To: Borough of Milltown Planning Board

Date: August 26, 2020

Re: Heritage of Milltown
149, 153, and 161 South Main Street
Block 76, Lots 1, 2.02, and 4
Minor Subdivision

Zoning

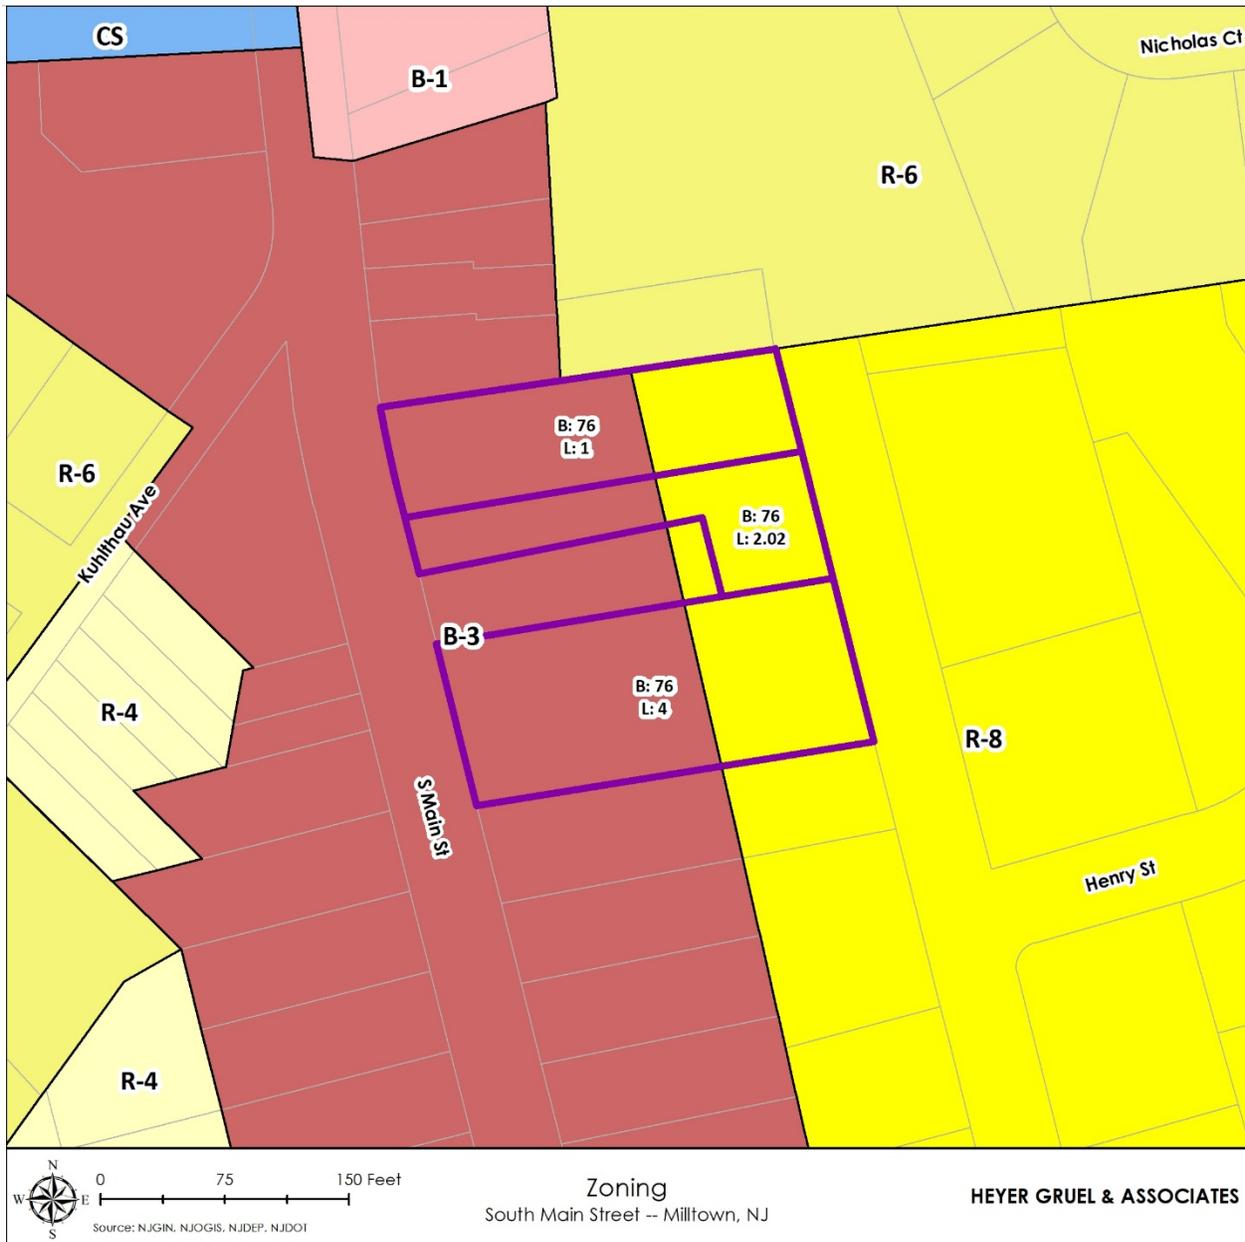
- 3) The zone line shown on the subdivision plan is described as "approximate". It does not appear to match the most recent version of the Borough zoning map, which depicts the westward jog

in the line between the B-3 and R-8 Zones one property to the north of where it is shown on the subdivision (see zoning map on page 4 of this report). The applicant should correct the zone boundary on the plans.
